RESOLUTION HOLDING HEARING ON REQUEST FROM CASEY’S MARKETING COMPANY FOR APPROVAL OF PUD FINAL DEVELOPMENT PLAN FOR “CASEY’S STORE NO. 1192” FOR PROPERTY AT 3200 SOUTHWEST 9TH STREET

Communication from the City Plan and Zoning Commission advising that at their meeting held May 5, 2020 the following action was taken regarding a request from Casey's Marketing Company (lessee) represented by Marni Beck (officer) for review and approval of a PUD Final Development Plan "Casey's Store No. 1192" for property located at 3200 Southwest 9th Street, to allow redevelopment of the existing 21,664-square foot general food sales store with a 4,817-square foot gas station/convenience store to include a pump island canopy with 14 fueling locations. The subject property is owned by Tursi, LC.

CASEY'S GENERAL STORE NO. 1192

SHEET
 C-201

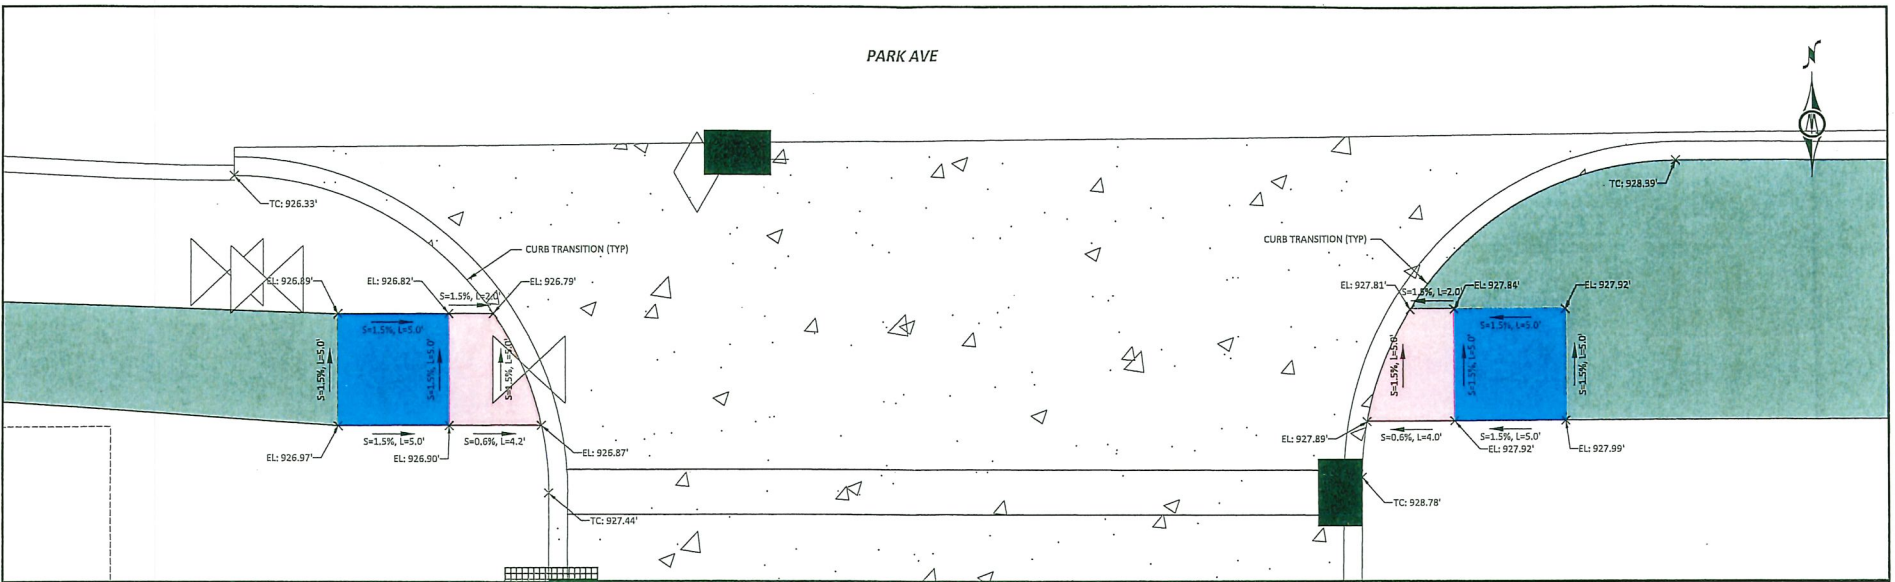
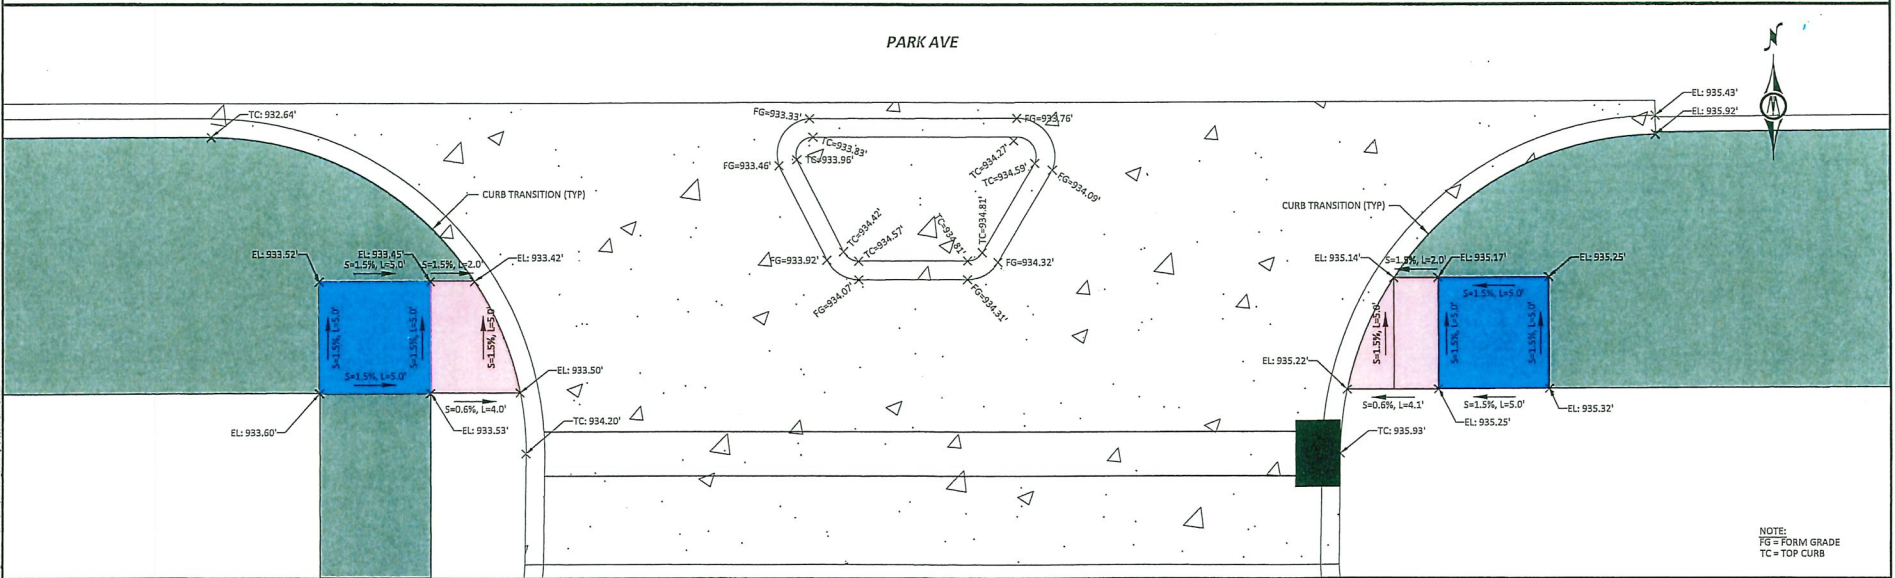
Underground stormwater storage chambers are proposed on the northwest portion of the site to manage required stormwater detention (see Sheet C-201 of submitted Final Development Plan). These chambers would outlet into public storm sewer available in Park Avenue at the northwest corner of the site.
